Access Compliance Report

Public Rights-of-Way

(Pedestrian Signals)

Intersection ID: N/A	Main Street:	Cross Street: N/A	Location: N/A
ADA ID: 06D6647CF8EE	Signal Type: One Push Button-Non APS	Overall Compliance: No	Severity Score: BTN 1: N/A BTN 2: N/A No BTN: N/A
Codes/Mitigation Info/Possible Solution		Field Measurements/Component Compliance

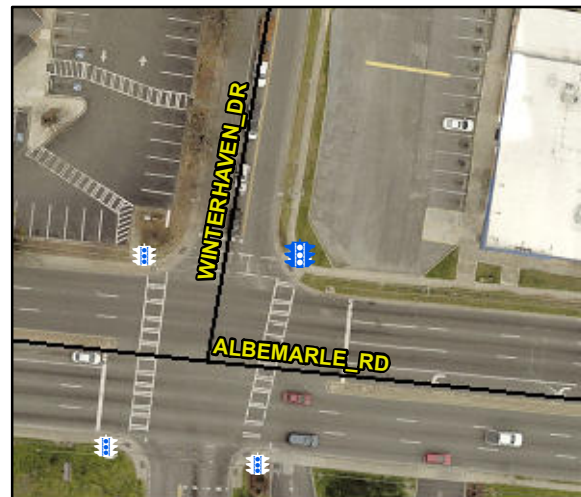
Surveyor Notes: TEXT HT 7/16

PROW/ADA: R410.6, R209.1, TMUTCD 4e.08, R404.2, R404.3, R406.2, R404.7.3

Compliance	Description	Data	Compliance	Description	Data
	Button Count	Button1	N/A	Distant to Additional Button (in)	N/A
	Additional Button Present?	No		Additional Button ID	N/A
N/A	Signal Buttons Required?	N/A	N/A	Additional Ped Posts Required	N/A
	How Many Ped Street Xings?	2		Located In An Island/Median?	No
N/A	B 1 Sign Present?	Yes	N/A	B 2 Sign Present?	N/A
Yes	B 1 Sign Purpose?	Yes	N/A	B 2 Sign Purpose?	N/A
No	B 1 Sign Lettering & Contrast?	No	N/A	B 2 Sign Lettering & Contrast?	N/A
No	B 1 Parallel To XWalk?	No	N/A	B 2 Parallel To XWalk?	N/A
Yes	B 1 PAR to Button?	Yes	N/A	B 2 PAR to Button?	N/A
Yes	B 1 PAR to XWalk?	Yes	N/A	B 2 PAR to XWalk?	N/A
Yes	B 1 Clear Floor Space?	Yes	N/A	B 2 Clear Floor Space?	N/A
N/A	B 1 FWD Approach?	Yes	N/A	B 2 FWD Approach?	N/A
N/A	B 1 FWD Approach Constrained?	No	N/A	B 2 FWD Approach Constrained?	N/A
No	B 1 FWD Approach Reach (in)	14.0	N/A	B 2 FWD Approach Reach (in)	N/A

N/A	B 1 FWD Approach Width (in)	N/A	N/A	B 2 FWD Approach Width (in)	N/A
N/A	B 1 FWD Approach Obstruction?	Yes	N/A	B 2 FWD Approach Obstruction?	N/A
N/A	B 1 FWD Approach Obstruction Dist (in)	9.0	N/A	B 2 FWD Approach ObstructionDist (in)	N/A
N/A	B 1 PARA Approach?	Yes	N/A	B 2 PARA Approach?	N/A
N/A	B 1 PARA Approach Constrained?	No	N/A	B 2 PARA Approach Constrained?	N/A
No	B 1 PARA Approach Reach (in)	11.0	N/A	B 2 PARA Approach Reach (in)	N/A
N/A	B 1 PARA Approach Width (in)	N/A	N/A	B 2 PARA Approach Width (in)	N/A
N/A	B 1 PARA Approach Obstruction?	Yes	N/A	B 2 PARA Approach Obstruction?	N/A
N/A	B 1 PARA Approach Obstruction Dist (in)	9.0	N/A	B 2 PARA Approach ObstructionDist (in)	N/A
No	B 1 Clear Floor Space Slope (%)	6.1	N/A	B 2 Clear Floor Space Slope (%)	N/A
No	B 1 Clear Floor Space XSlope (%)	6.0	N/A	B 2 Clear Floor Space XSlope (%)	N/A
N/A	B 1 PAR Slope (%)	4.9	N/A	B 2 PAR Slope (%)	N/A
Yes	B 1 Height (in)	43.5	N/A	B 2 Height (in)	N/A

Yes	B 1 Clear Xing Direction?	ClearlyMarked	N/A	B 2 Clear Xing Direction?	N/A
	B 1 Crossing Direction	To S		B 2 Crossing Direction	N/A
Yes	B 1 DistanceTo XWalk (in)	22.0	N/A	B 2 DistanceTo XWalk (in)	N/A
No	B 1 DistanceTo Curb (in)	142.0	N/A	B 2 DistanceTo Curb (in)	N/A
Yes	B 1 Diameter (in)	2.0	N/A	B 2 Diameter (in)	N/A

Possible Solutions: Replace Signal Push Button With APS Button on New Post. Remove & Replace Sign.
